Access Compliance Report

(Curb Ramps)

Intersection ID: 13605	Main Street: CHARLOTTETOWNE_AV	Cross Street: E_5TH_ST	Location: E
ADA ID: 1EBA4D281393	Ramp Type: Perp	Initial Pass/Fail: Fail	Overall Compliance: No
Severity Score: 8.75			
Codes/Mitigation Info/Possible Solution		Field Measurements/Component Compliance

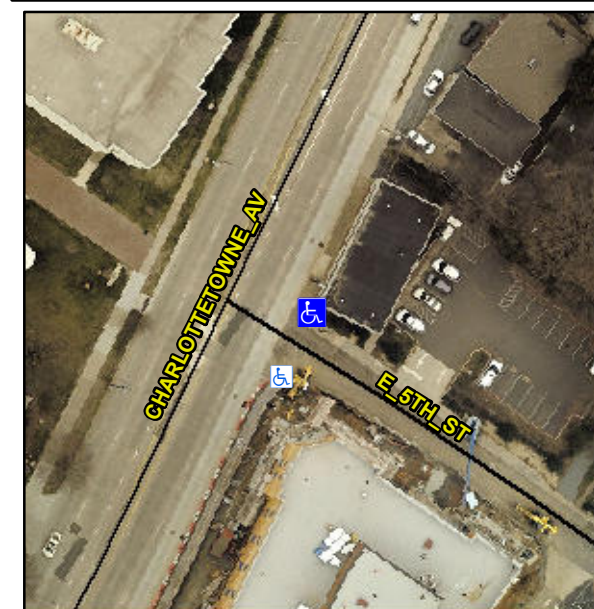
R304.5.1

Remove & Replace Entire Ramp.
